WATER LICENCE INSPECTION FORM

☒ Follow-Up Report

Licensee	Licensee Representative
City of Iqaluit	Joe Brown
Licence No. / Expiry	Representative's Title
3AM-IQA1626	NA
Land / Other Authorizations	Land / Other Authorizations
	--
Date of Inspection	Inspector
6/10/2021	Jonathan MESHER
Activities Inspected	
☐ Camp	☐ Drilling
☐ Roads/Hauling	☒ Other: Landfill
☐ Mining	☐ Construction
	☐ Other:
☐ Reclamation	☐ Fuel Storage

City of Iqaluit
West 40 Landfill
Berm and Fencing

Photo 1

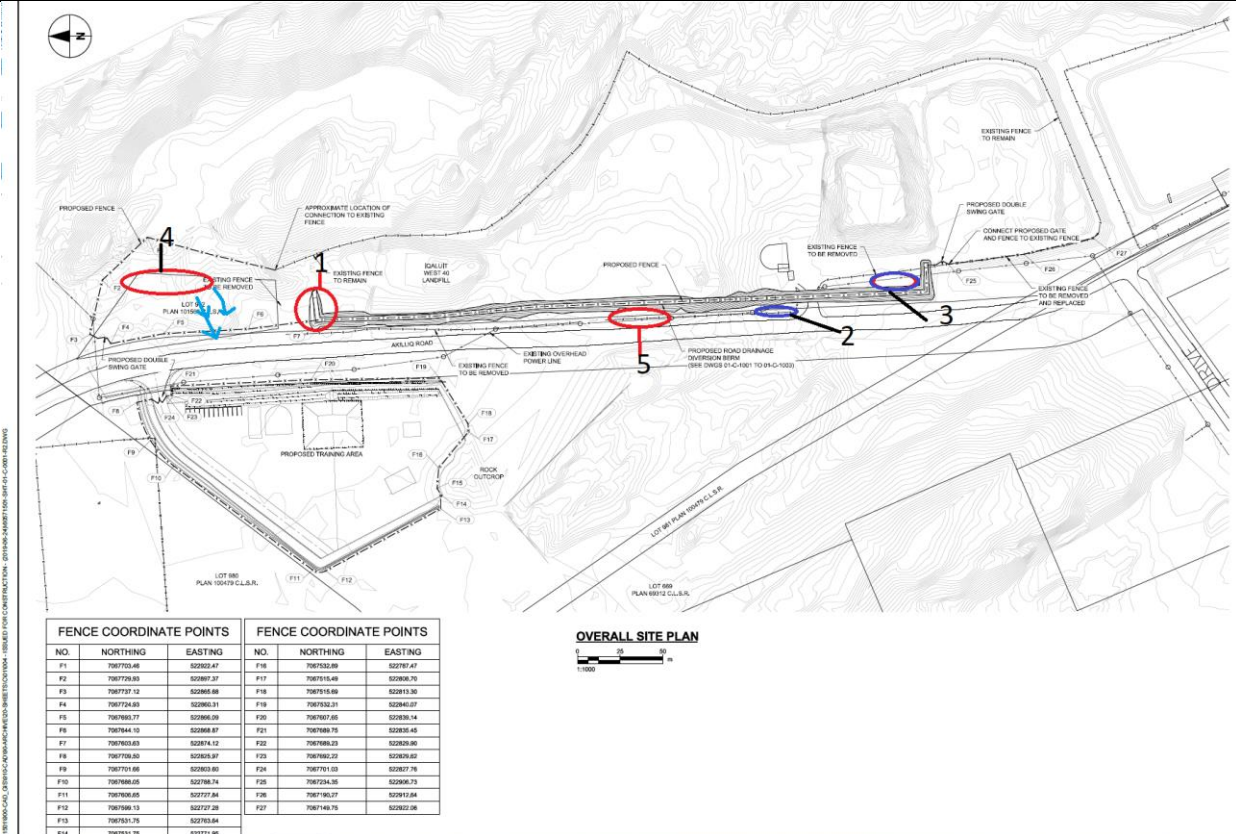
1. Concerns related to; 60571501-SHT-01-C-COMPILED IFC SIGNED 2019-07-12.pdf (fence and berm for construction drawings)

C. The North side of the berm is missing a section of the berm identified in Photo 1, item, leachate from the Northwest side of the facility is diverted north along the berm to a area with no containment, this leachate appears to be able to flow freely into the receiving environment.

D. In photo 1, item 3, the city has constructed a low lying area where water is pooling, in the 2011

drainage plan it shows onsite drainage to flow from the southwest side of the facility into the containment pond at the south side of the facility. There are no drainage ditches to allow this drainage to occur nor is the facility appropriately graded to promote this flow of leachate to its containment pond. The 2011 Site drainage plan needs to be updated as the municipal refuse is not contain by berms or ditches that promote the flow of leachate to its containment ponds.

6. In the 2011 drainage plan the City indicates that the non contact water/offsite drainage will flow past the shop to the south, the licensee has blocked this flow path and the water is currently creating a pond north of the entrance, this is shown in Photo 1 item 2 and in photo 3.

Photo 2

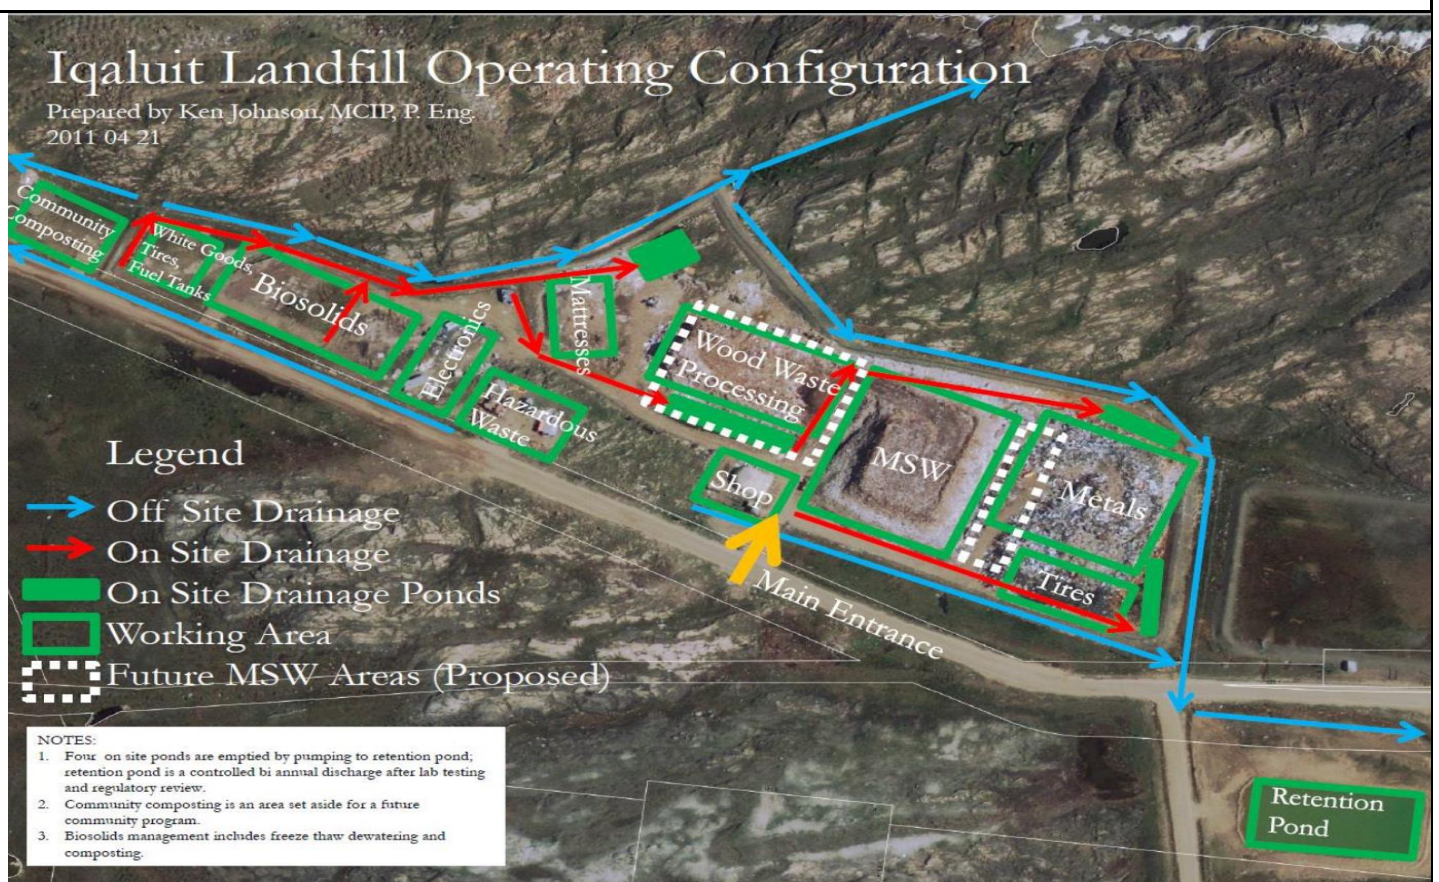
Description: out dated drainage plan.

Photo 3

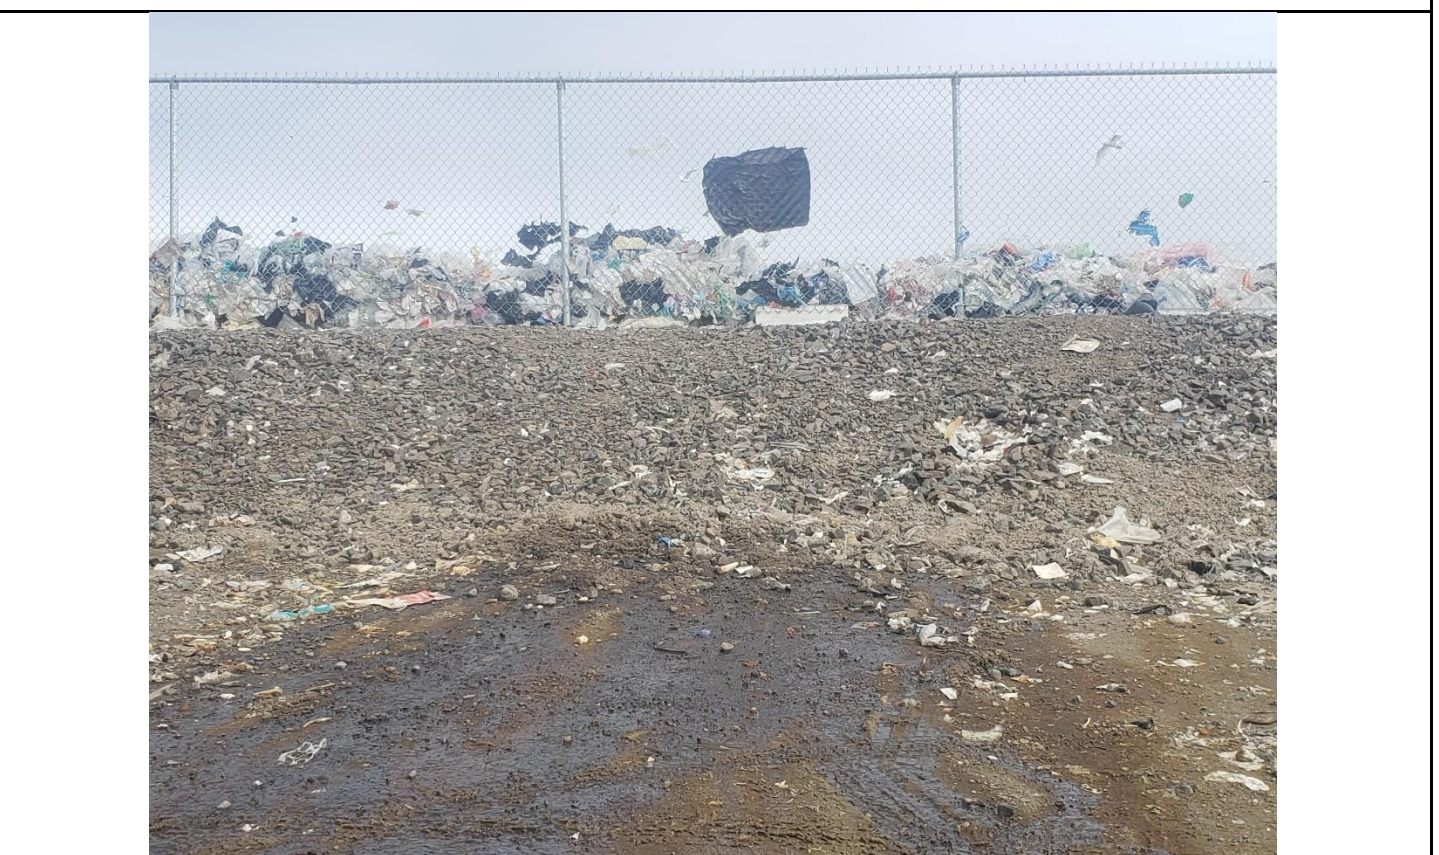
- E. At the approximate location N63.7344 W68.5365 there is pooing water inside the landfill, on the outside of the Landfill adjacent to the location there appears to be water seeping through the berm. Please ensure this waste water is removed and the area is properly graded to stop the leachate from leaving the Landfill. See photo 3 below for the seepage.

Description: seepage from pooling water within the landfill.

- 4) The licensee is to remove the pooling water from within the landfill and ensure the grade of the facility promotes flow to the containment ponds to minimize animal, insect infestation and seepage from the unlined berms.
- 5) To prevent the mixing of paints and other hazardous wastes with water the inspector is recommending that the licensee keep sea cans used for storage of hazardous waste closed when not in use.
